Re: Better Brite

SUBJECT: Further evaluation of effectiveness of soil stabilization and potential for off-site migration of chromium contaminated groundwater at the Better Brite, Chrome Shop

TO: Keld Lauridsen, State Project Manager, WDNR

BETTER BRITE DePERE, WISCONSIN		DATE: 05/18/95
CHROME SHOP SURFACE SOIL EXCAVATION EXTENT 1993		DESIGNED: RAG
		CHECKED: JEN
		APPROVED: JLF
		DRAWN: RAG
		PROJ: 301483158
 HYDRO-SEARCH INC A Tetra Tech Company		Figure 2-13

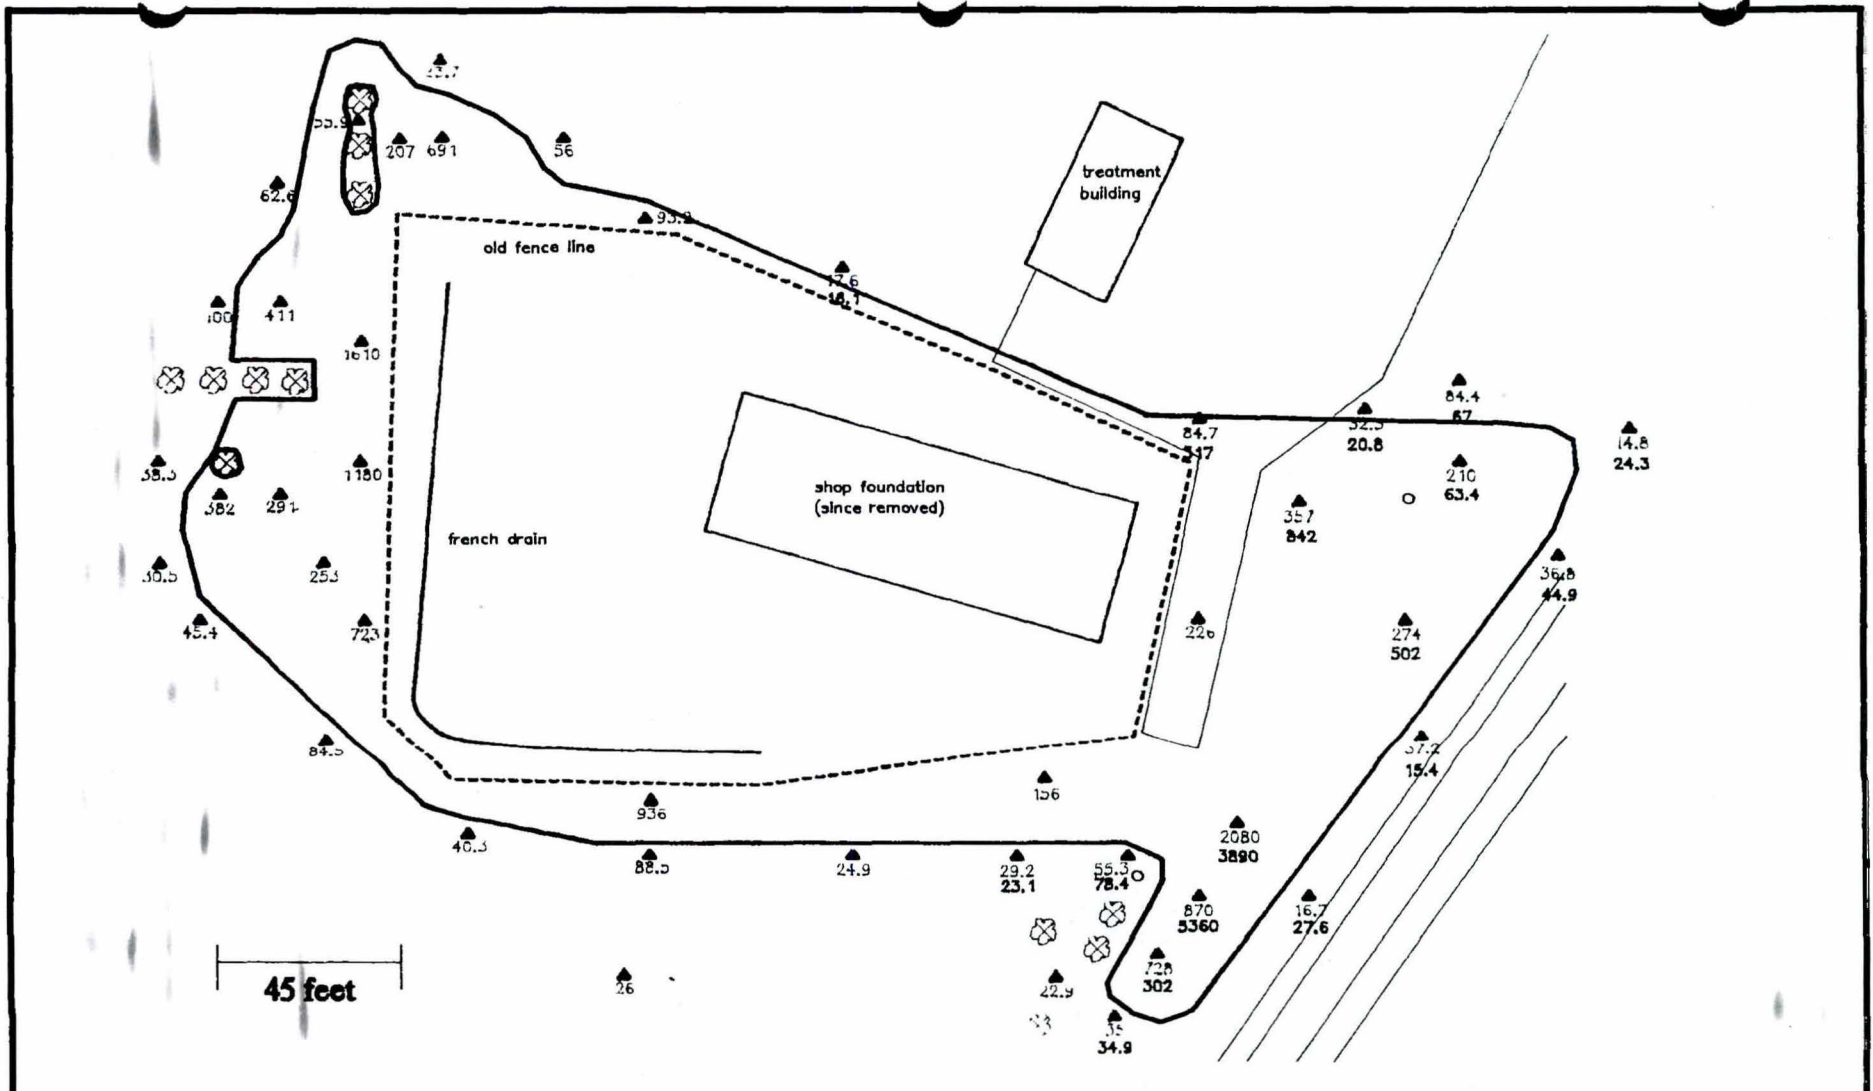
2. sand fill beneath the foundation.
3. surface soil from around the Chrome Shop and on properties adjacent (see attached Figure 2-13 from *Remedial Investigation Better Brite Plating, Inc.*, Hyrdo-Search, March 13, 1996). Surface soil was excavated to depths of approximately 1.0 to 1.5 feet. Analytical data for surface (0 to 0.5 feet bgs) and subsurface (2.5 to 3.0 feet bgs) soil samples collected from across the Chrome Shop and adjacent properties were used to define the extent of surface soil impacts and direct the excavation activities. This data along with the removal of garden soil by Better Brite in 1980 indicates that contamination from surface run-off extended well beyond the Chrome Shop property.

Considering the slow rate of groundwater movement, that the French drain started in operation only one year after start of the Chrome Shop operation, and that the area of soil contamination includes the area of groundwater contamination (compare attached figures), it appears that the groundwater contamination by chromium outside of the property boundaries (about 50 feet to

BETTER BRITE DePERE, WISCONSIN PROPOSED WELL LOCATIONS CHROME SHOP	DATE: 12/1/99
	DESIGNED: BOB
	CHECKED: KEB
	APPROVED: JLF
	DRAWN: BOB
	PROJ: F119
Figure 7-3

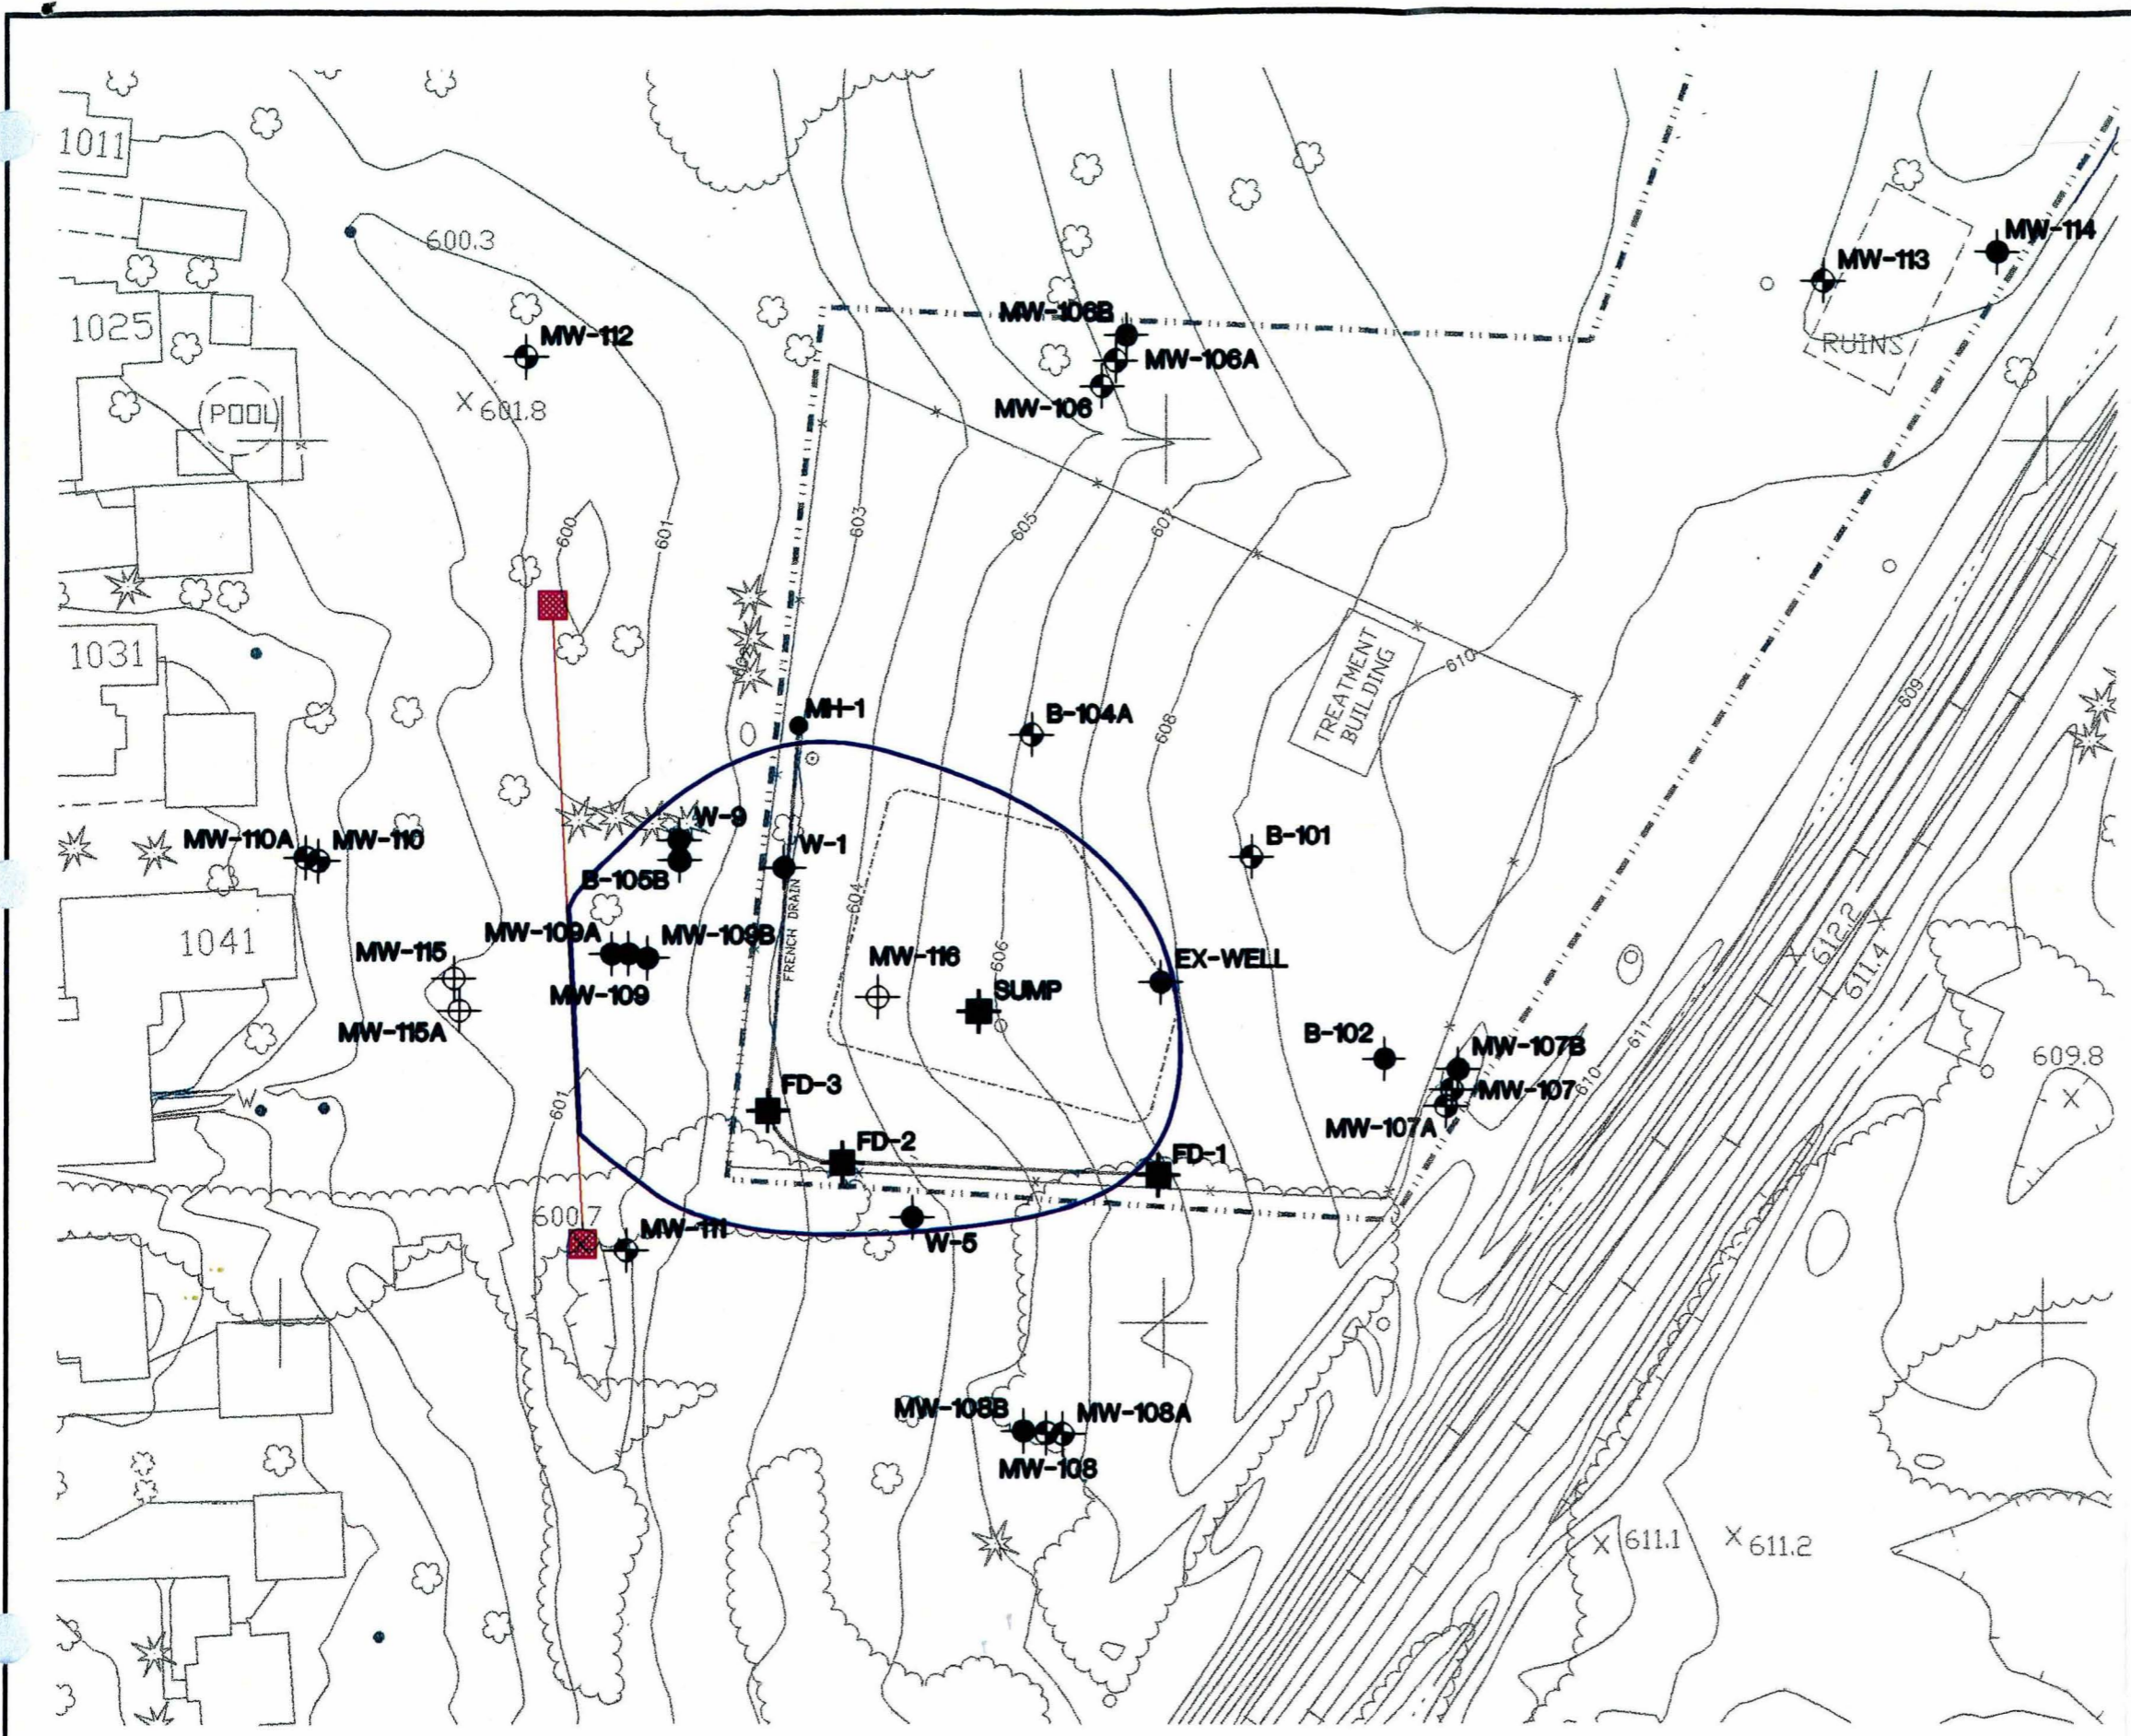
1. The sump area (see approximate limits of excavation are shown by the sump boundary on Figure 7-3). Soil was excavated to a depth of approximately 20 feet below ground surface (bgs). Soil samples collected from the bottom of the excavation confirmed that the soil left in place was not impacted with metals.

In 1999, natural soils and fill soils and gravel within the area of groundwater contamination (see Figure 7.3) were treated to a 20 foot depth by mixing with a proprietary reagent primarily consisting a blend of iron sulfates. The intention of the treatment was to reduce Cr^{+6} to insoluble and less toxic trivalent chromium (Cr^{+3}), so that Wisconsin groundwater standards would be achieved quickly and no further groundwater withdrawal or treatment would be required. In addition in 1999, the Chrome Shop groundwater treatment plant was relocated to the Zinc
